ITEM FOR ENVIRONMENTAL BOARD AGENDA

**NAME & NUMBER
OF PROJECT:** WEBB ESTATES
C8J-2008-0082

MEMORANDUM

SUBJECT: Webb Estates C8J-2008-0082

WEBB ESTATES
PRELIMINARY PLAN
SLOPE MAP - TURKEY CREEK WATERSHED

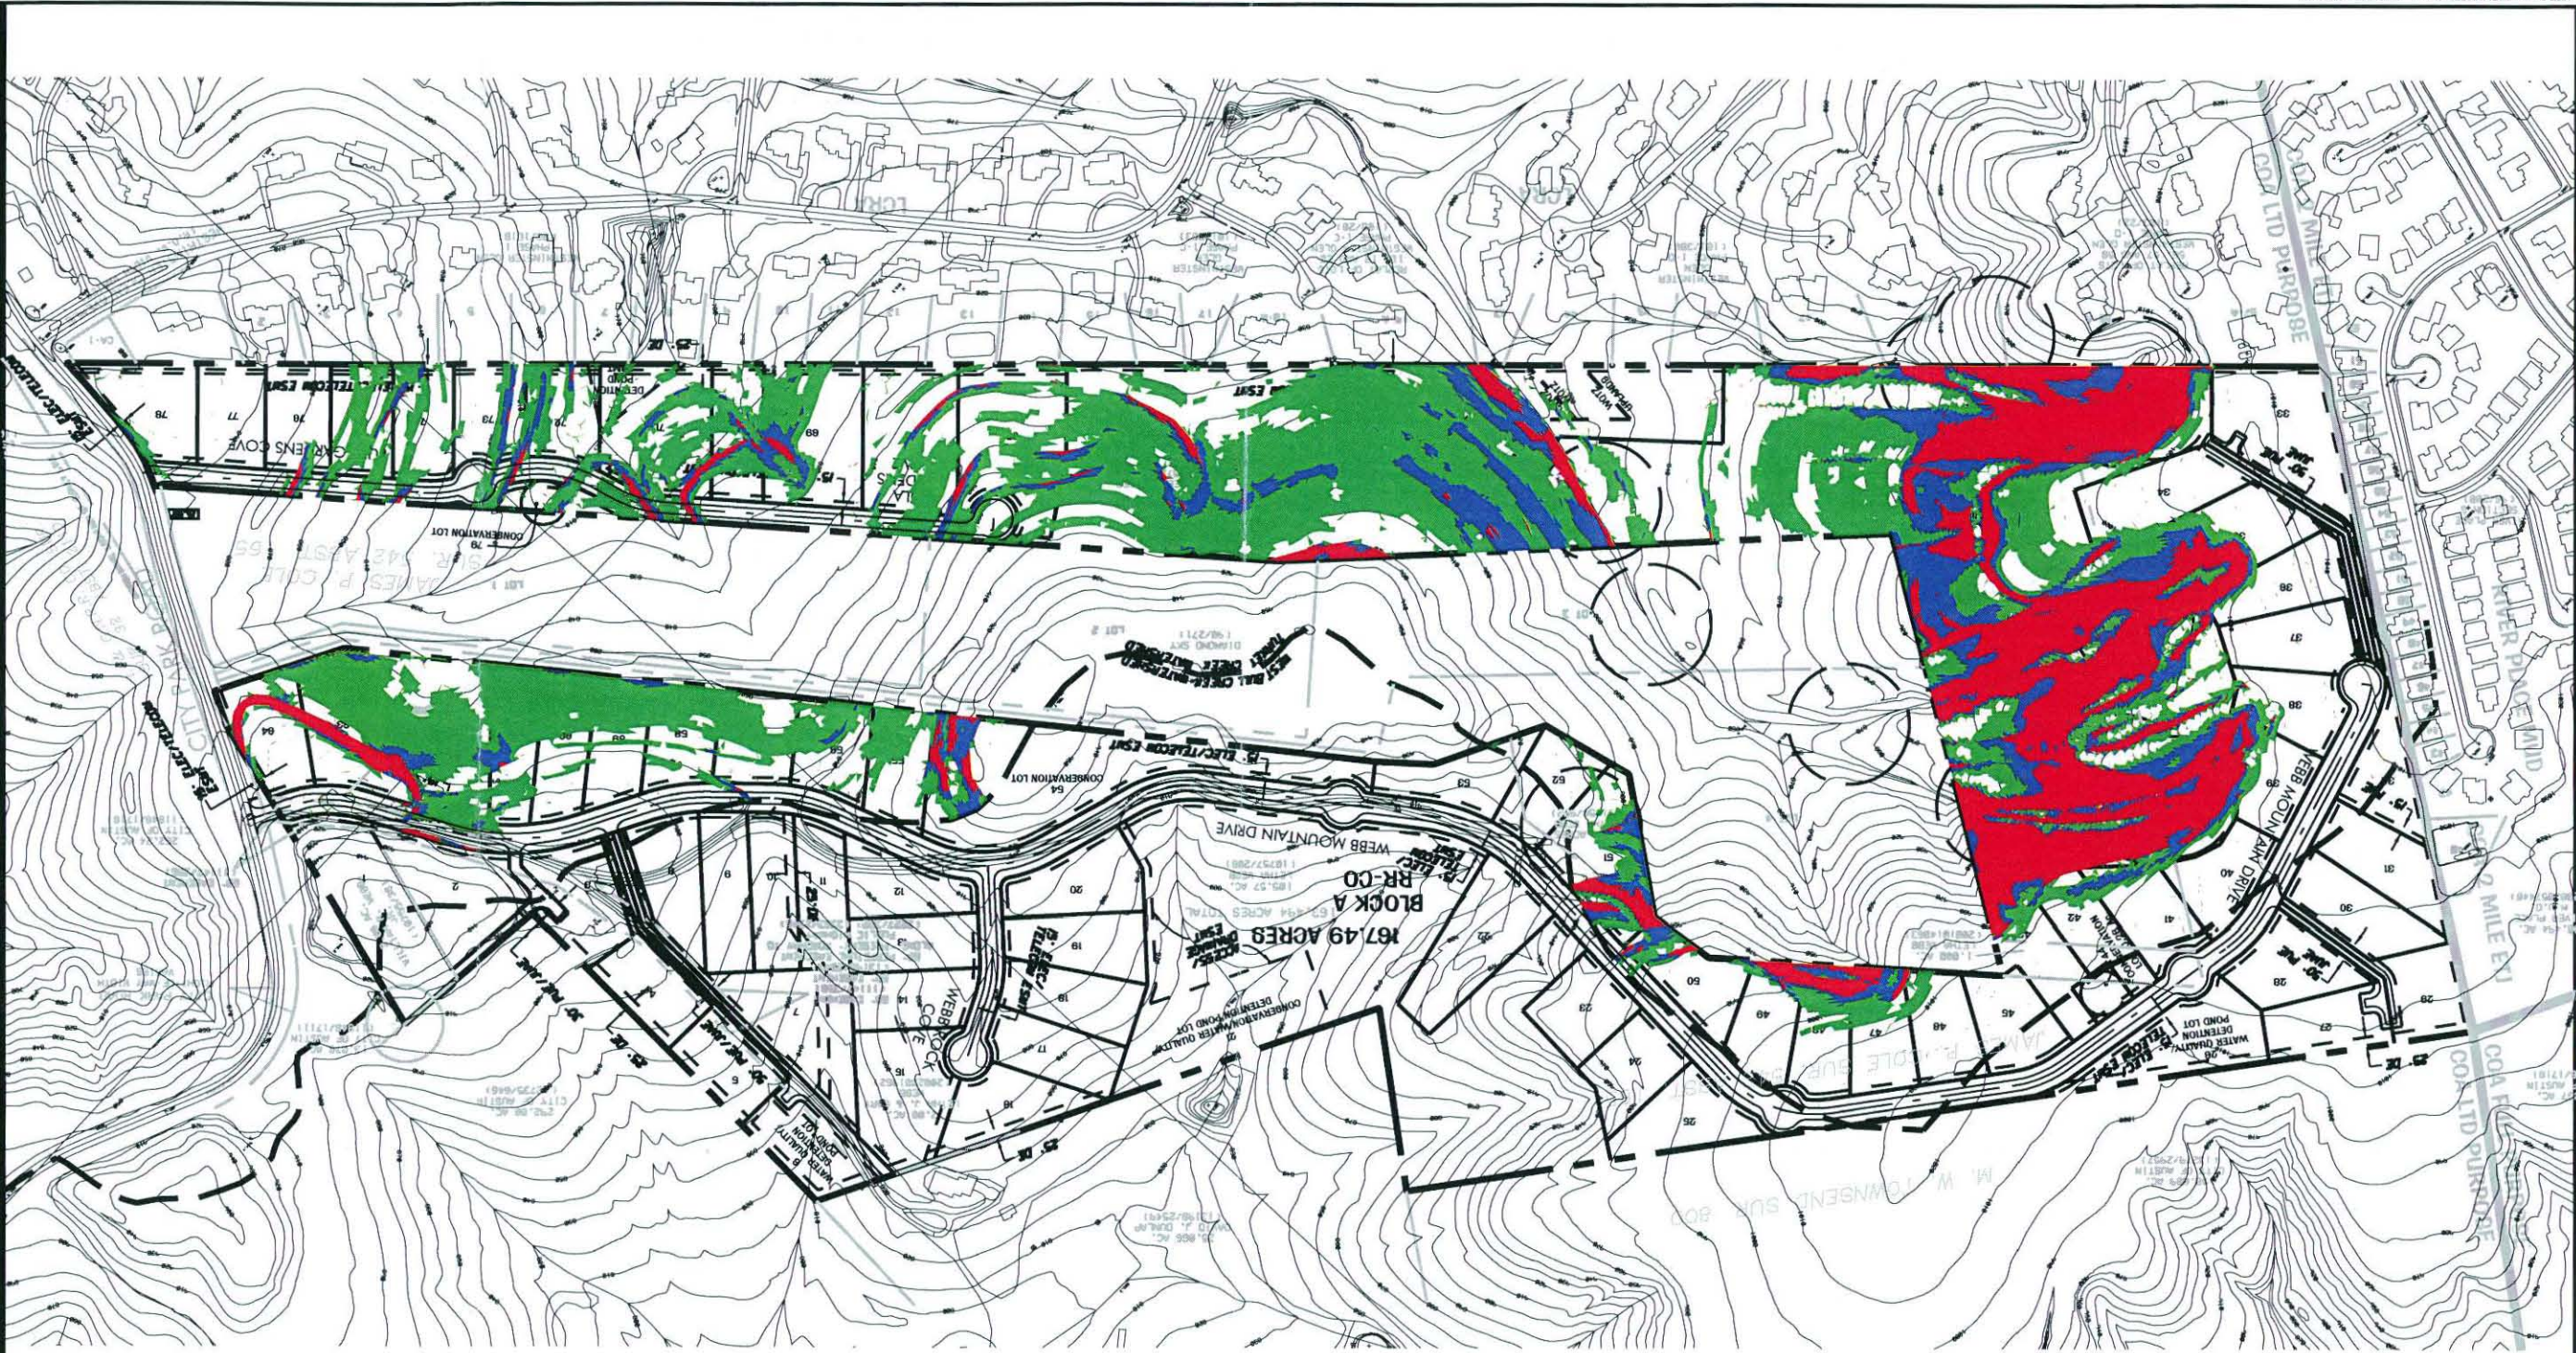
1. Variance from City Code Section 30-5-301(A)- Construction of roadway and driveways on slopes > than 15%.

2. Variance from City Code Section 30-5-302(B)- Construction of a building on slopes greater than 25%.

WEBB ESTATES (C8J-2008-0082) **CUT & FILL VARIANCE REQUEST EXHIBIT**

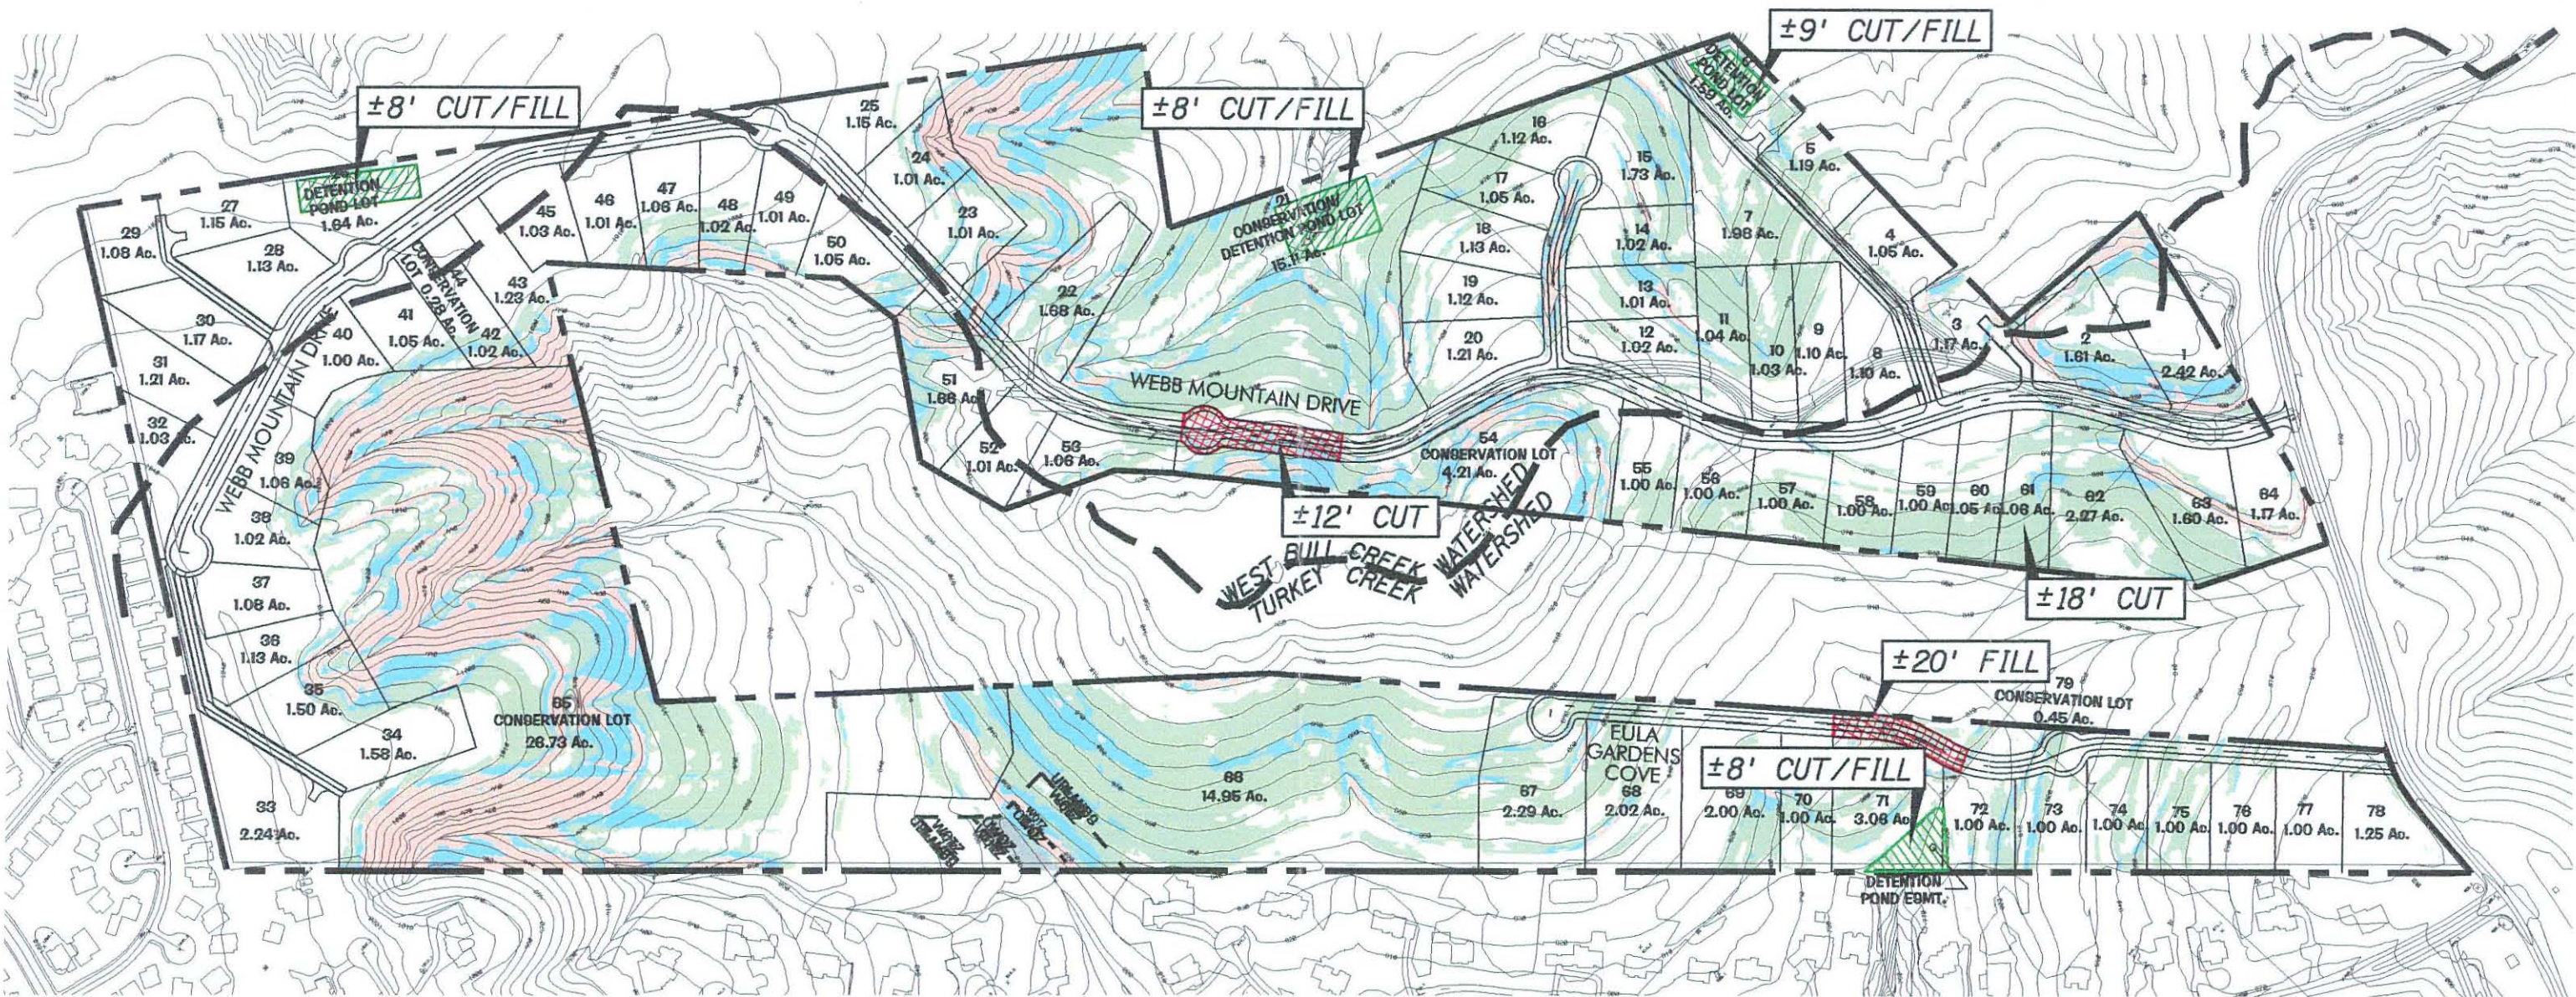
3. Variance from City Code Section 30-5-341- Cuts up to 18 feet.
Variance from City Code Section 30-5-342- Fill up to 20 feet.

The applicant will need this cut/fill variance to complete the central sections of both roads accessing the lots in this subdivision. On Webb Mountain Drive, the maximum proposed cut/fill is 12 feet. On Eula Gardens Cove, the maximum fill proposed is 20 feet.

Cut/fill will be necessary to construct driveways and/or single family residential buildings on individual lots where either the driveway must cross steep slopes, or on building sites which are located on the steeper bands of this Hill Country topography. Because home builders, not the applicant, will be locating and building the homes and associated driveways in this subdivision, the applicant is not certain of the exact location of each home. As a result, the applicant has estimated the cut/fill necessary for those lots that will require cut/fill to build the home. The applicant shows that Lots 2, 5, 7, 9-17, 22-24, 51, 53, 55-63, 66-76 need cut/fill greater than four feet to construct the home. The maximum cut/fill of 18 feet is requested for Lots 7, 22, 63, and 75.

- 1 All slopes greater than 33% shall be stabilized with a permanent structure, unless it is a stable rock face;
- 2 Prior to subdivision plan permit, the applicant will retain a geotechnical engineer to determine rock stability and to make slope stabilization recommendations;

- 6 Implement a City approved Integrated Pest Management Plan;
- 7 Any fill greater than 4 feet will be structurally contained;
- 8 Provide slope related building setbacks on each lot to further protect the steeper portions of each property. These setbacks will be surveyed and shown on the plat prior to approval;
